ADDENDUM

ADD 02

Project Name:	Toronto Public Library: Pleasant View Library	ADD No.	02
Project Address:	575 Van Horne Ave North York, ON M2J 4S8	No Pages :	24 (Including Cover)
Project No.	22-008	Owner: :	TPL
Prepared By:	Duane Comins		
Date:	2025.05.16

PLAN - ROOF LEVEL

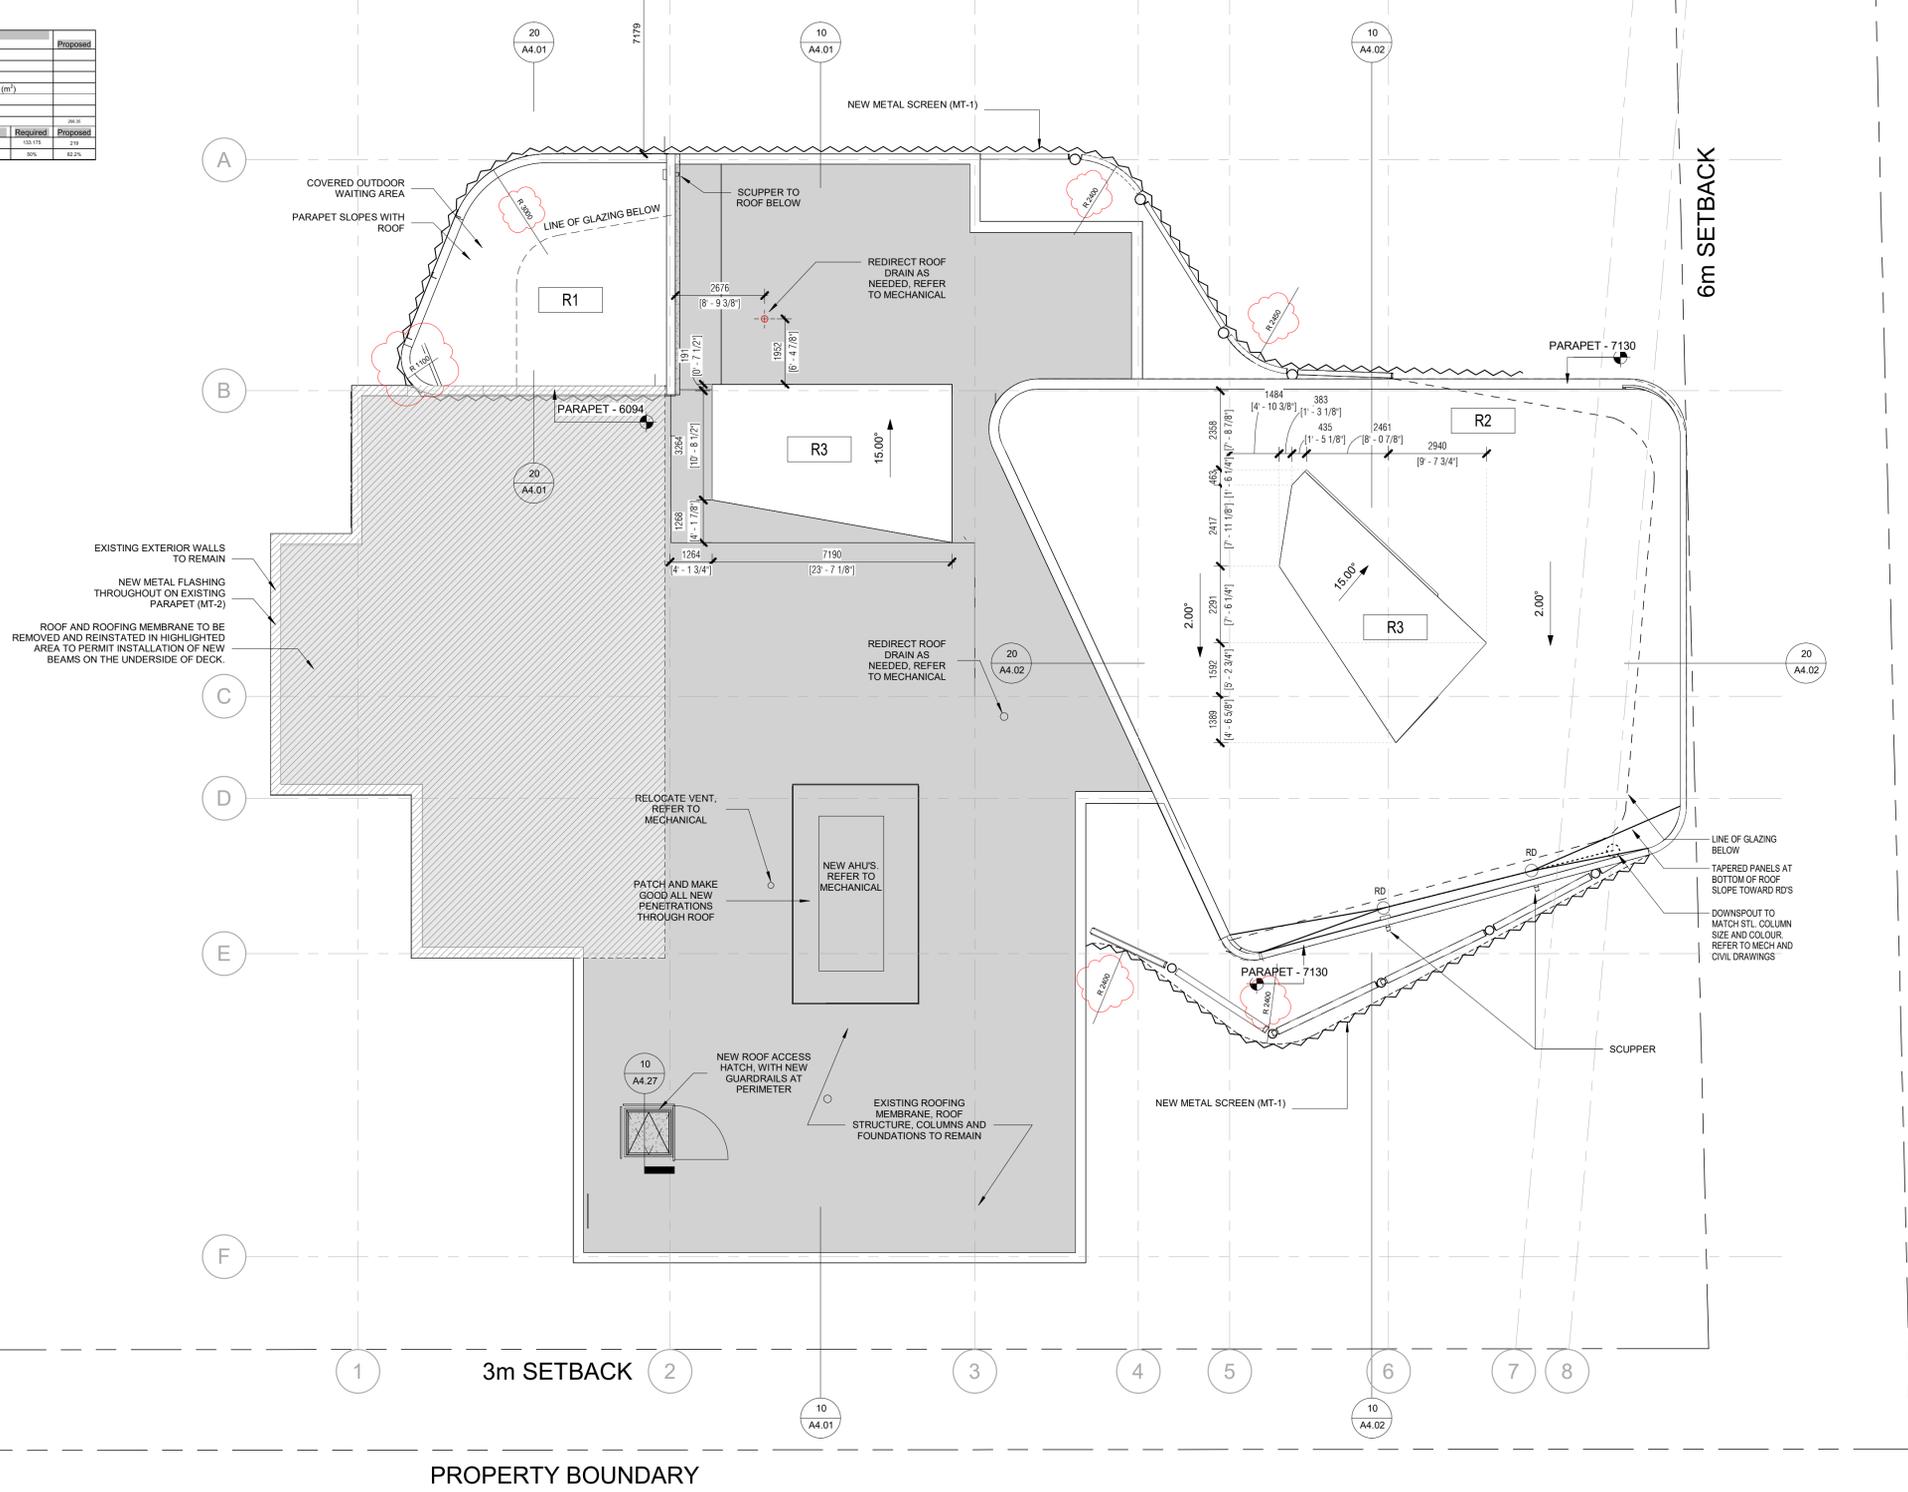
- 2.2 Question: Please provide plan with radiuses for all curved metal panels. Without this information it is impossible to understand (and price) this scope of work. Drawings show only some radiuses on elevations; however it is not sufficient.**

2.39 Question: Note 26 on A1.23 indicates roof & roofing membrane to be removed. The roof plan A2.12 indicates roof membrane to remain, roof structure and columns to remain. Which is correct?

Response: Please reference attached A2.12

CEILING FINISH DIAGRAM

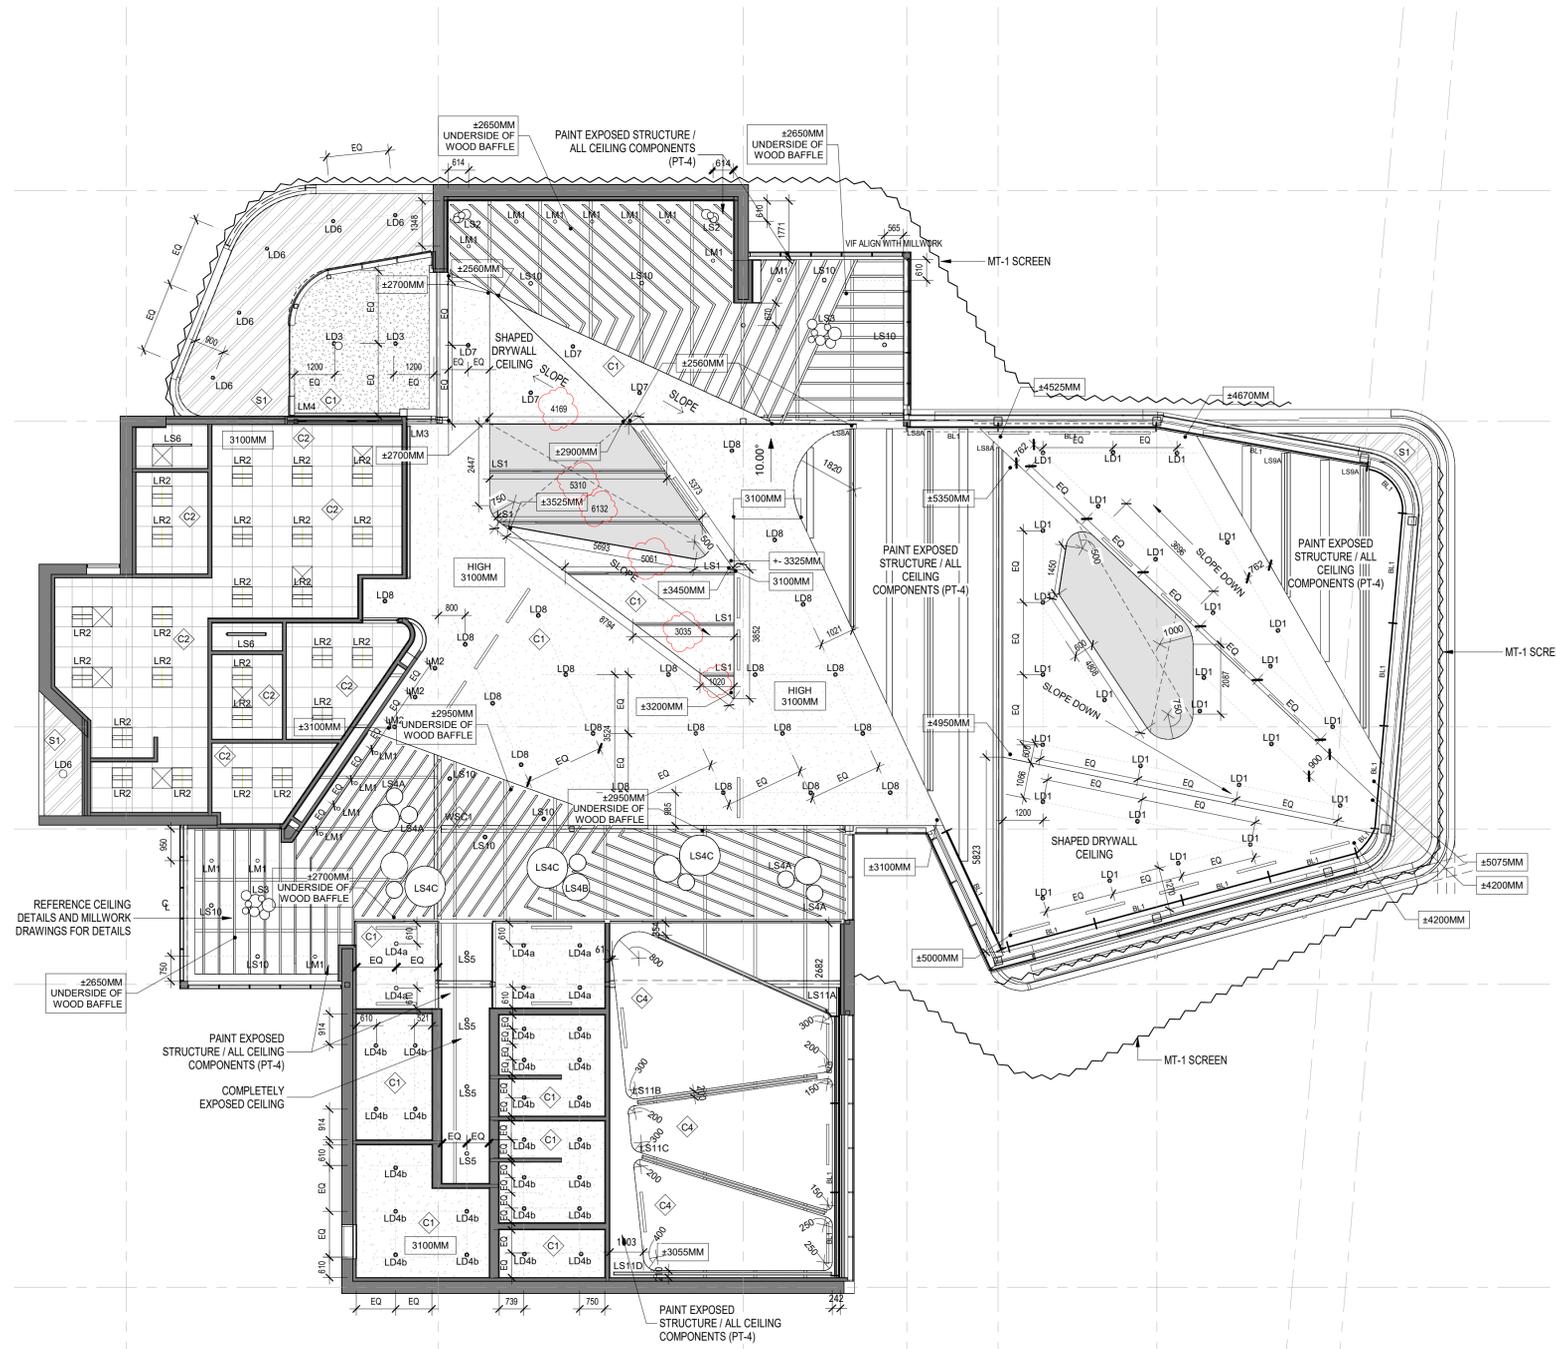
- 2.3 Question: Please revise the hatching on the reflected ceiling plan. Several areas are missing hatching and are shown in white, the same as the drywall ceiling. For example, in the Program Room, there's a note indicating an exposed ceiling, but no corresponding exposed ceiling symbol is shown in that room.**

2.40 Question: Please provide location for blinds.

Response: Please see attached additional diagram A2.33 for further clarification

Response: Location of blinds are located on A2.31 and A2.32
However, we have provided a clearer diagram attached here A2.33

S-101-E 30
1 : 50 A7.11

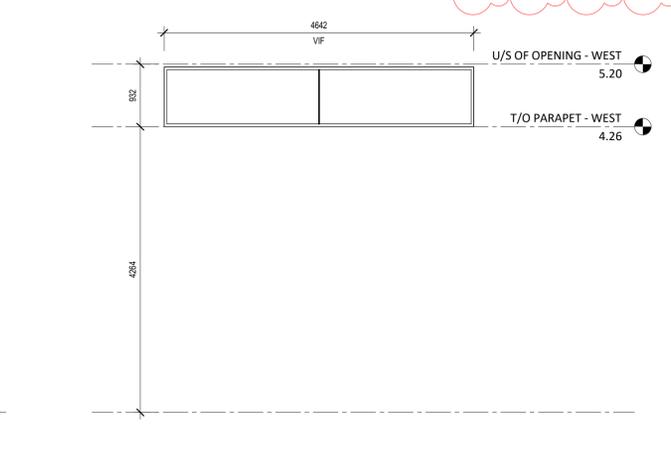
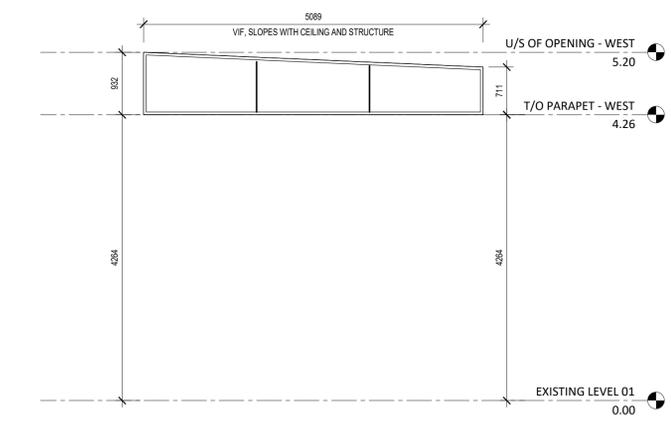
- 2.33 Question: Screen S-101-E is marked twice on window schedule. Drawing A7.11 and Drawing A7.15. Please clarify.**
- Response: S-101-E is clearstory between vestibule and staff office
S-101-F is vertical glazing between vestibule and circulation desk

- Response: These are clerestories. Refer to exterior elevations/building sections. S-101E/F are in vestibule 101. S-103-A is in Reception 103 clerestorey and S-123-I is in clerestorey in Stack 125 section.

GRL-1 TO CPT-3 10
1 : 5 A8.10

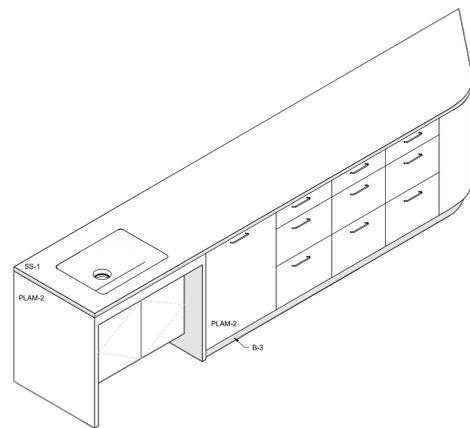
2.25 Question: Please confirm the intent for how we are to treat the joint where RAF-1 flooring meets RAF-1 up the wall.

Response: Please see additional detail on A8.10

A9.08

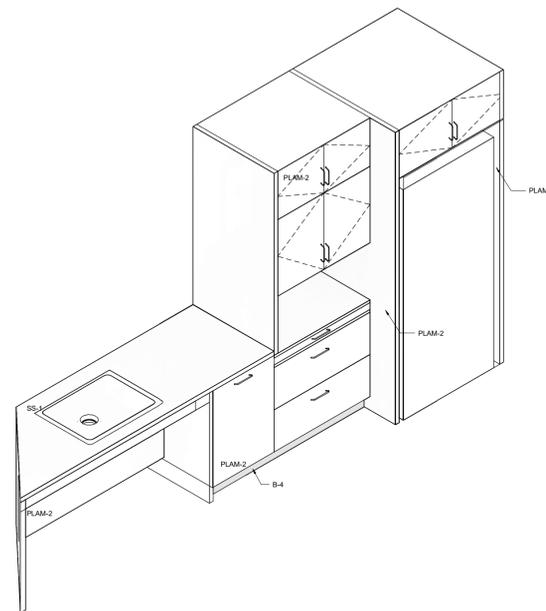
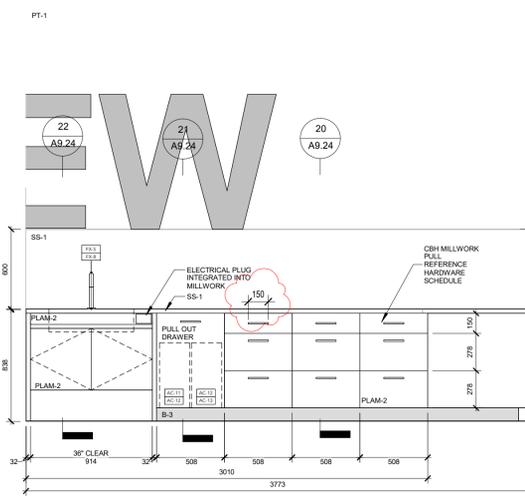
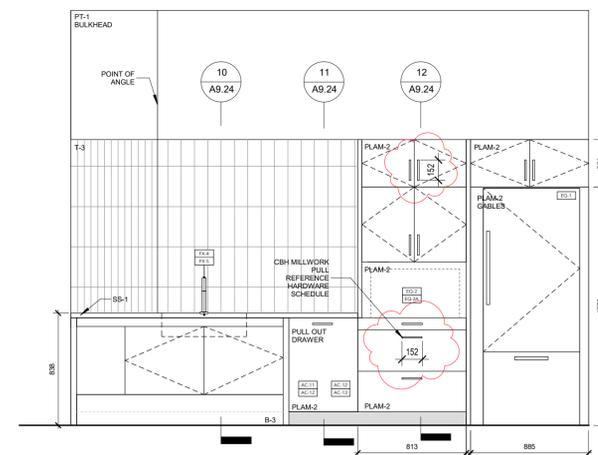
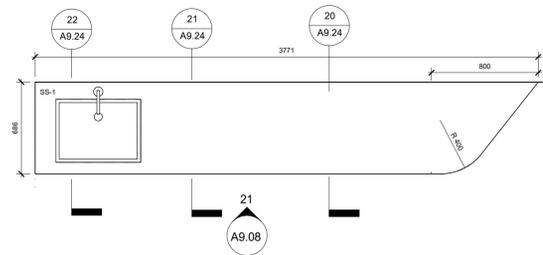
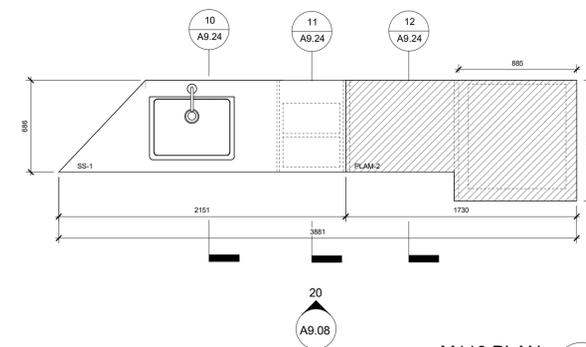
2.46 Question: Drawing A9.30: Please advise the intent for the cabinet pulls. Pull 2 has the same finish tag as pull 1 (C19) but the finishes are labelled differently. Also, if both pulls are noted 6" long but the elevations seem to reflect different pull lengths (e.g. Elevation 11/A6.13 illustrates pulls of different lengths - from approximately 4" to 10"). Please review and advise the intent.

Response: Correct, PULL-1 and PULL-2 are the same lengths but different finish dependent on locations
Yes, pull to be 6", Please see attached A9.08 for information on kitchenette / pantry

1 ENTRANCE SIGN - ELEVATION
(ALL DIMENSIONS IN METERS)

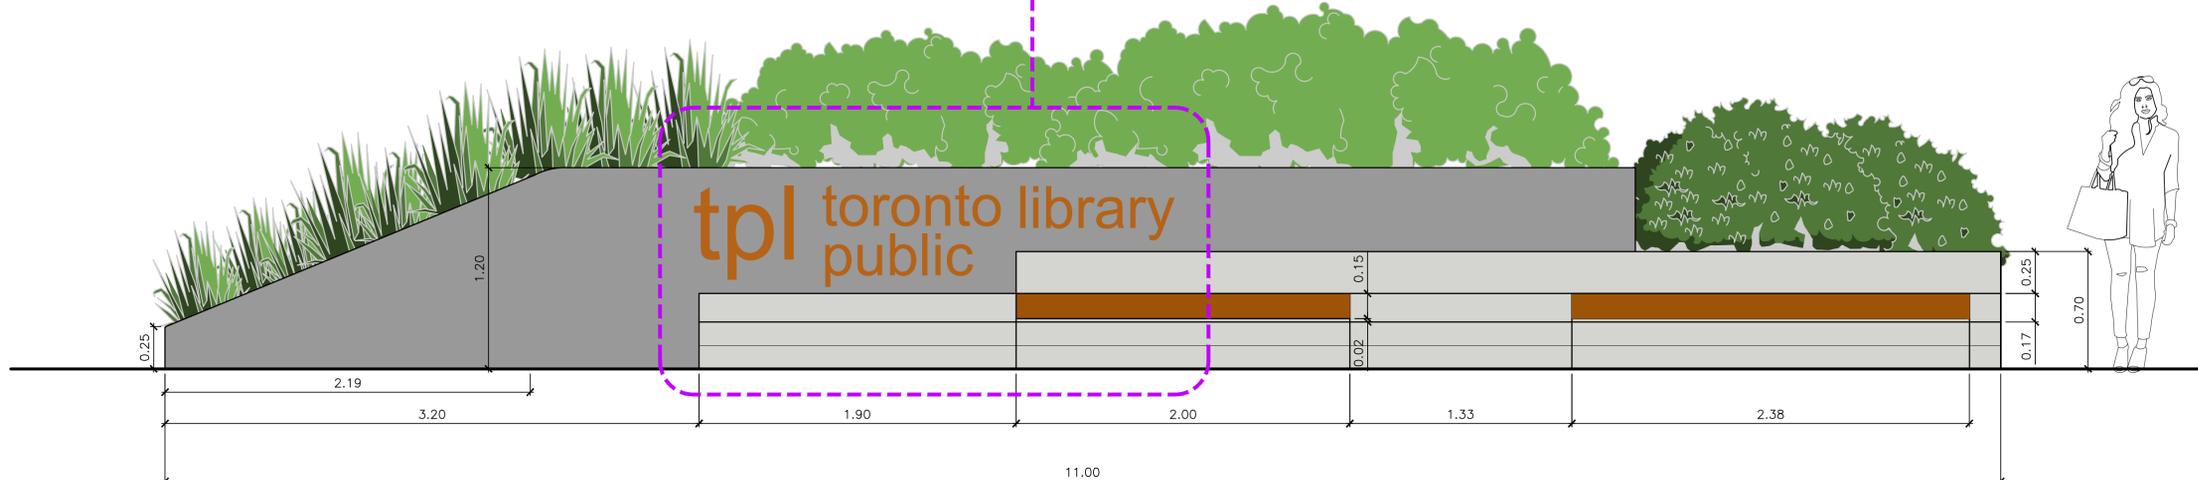
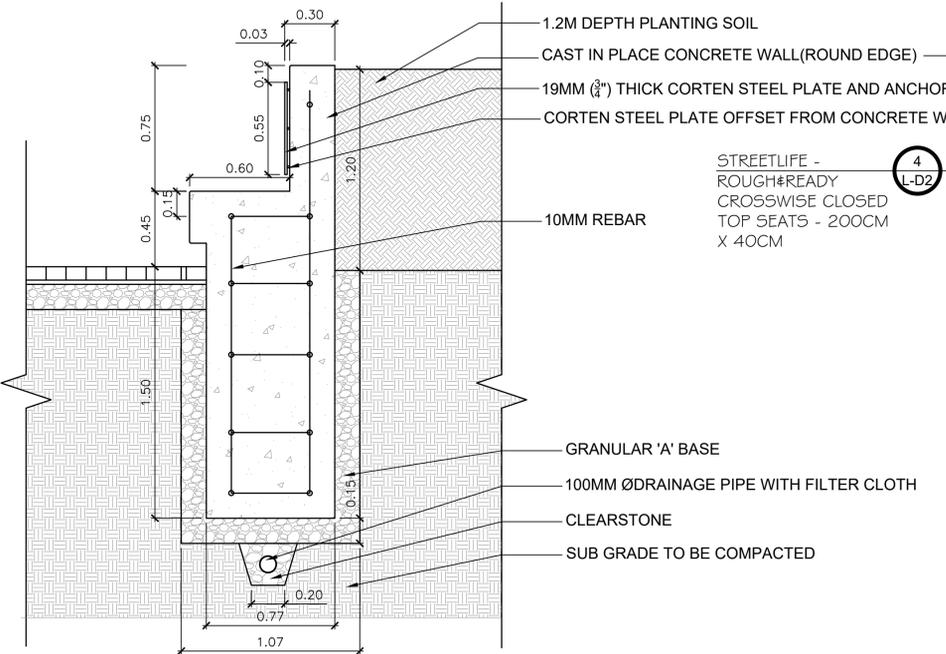
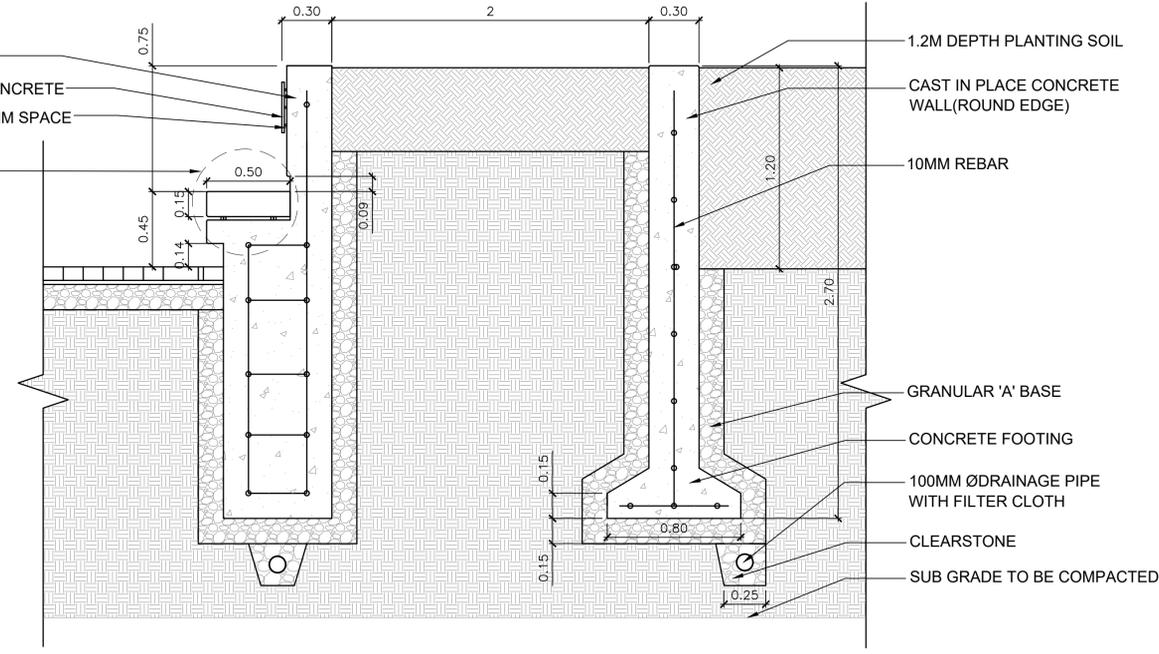
5.2 Question: Please provide information about 20mm thick metal plate on L-D3 including finish and location on elevation.

5.3 Question: Please provide scaled drawings for all the details and plans on L-D3.

Response: Detail descriptions are provided on page L-D3. The letters shall be laser-cut from 19mm (3/4") thick Corten steel plate.

An additional blow-up has been added to page L-D3, showing the letters overlaid with a 100mm x 100mm grid to indicate their location and elevation.

Response: All blow-ups shown on page L-D3 are to scale. Updated scale references have been added to each blow-up for clarity. Drawings can be manually measured using an appropriate scale bar on the hard copy printed at Arch D size (24" x 36").

3 PLAN - GROUND FLOOR
E-311 1:100

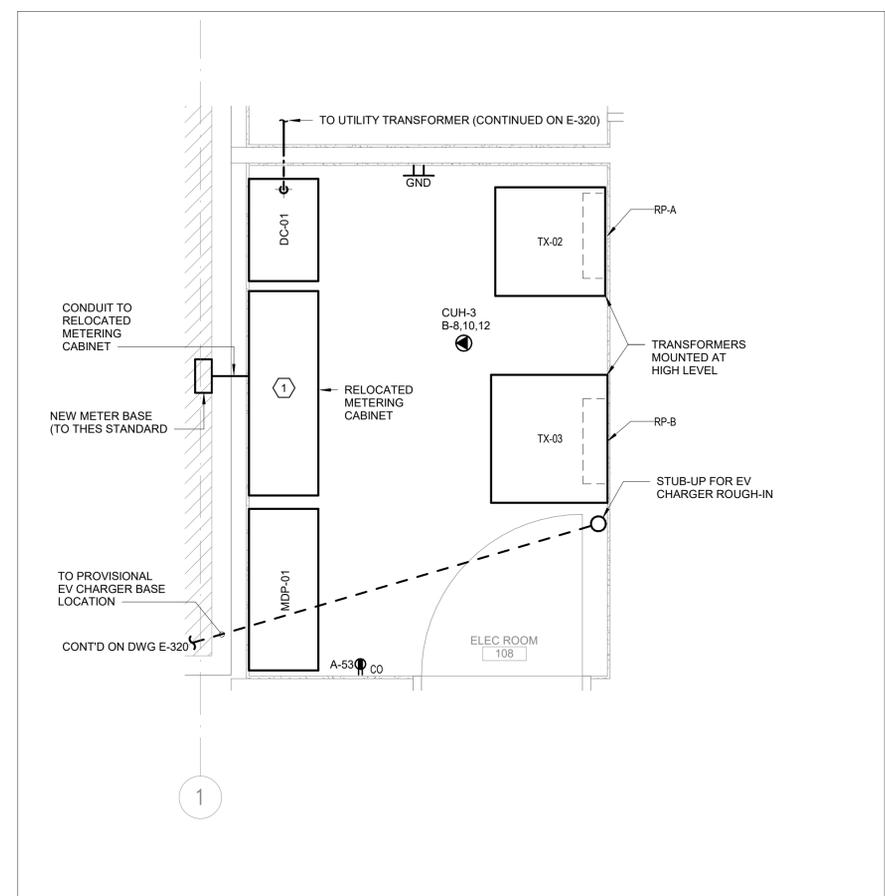
4.1 Question: Please clarify symbol showing "R" beside the floor box, is it new or relocated floor box? If it is new, please provide the specification.

4.2 Question: Please clarify "Flush-mounted concrete boxes" shown on E-311. No specification is provided.

Response: These are intended to be flush/recessed. The legend has been updated in the attached drawings

Response: Specification provided in the addendum.

- .1 Revise locations of power feeds to HUM-1 and EWH-1.
- .2 Add General Note 7.
- .3 Revise note for flush-mount concrete box.
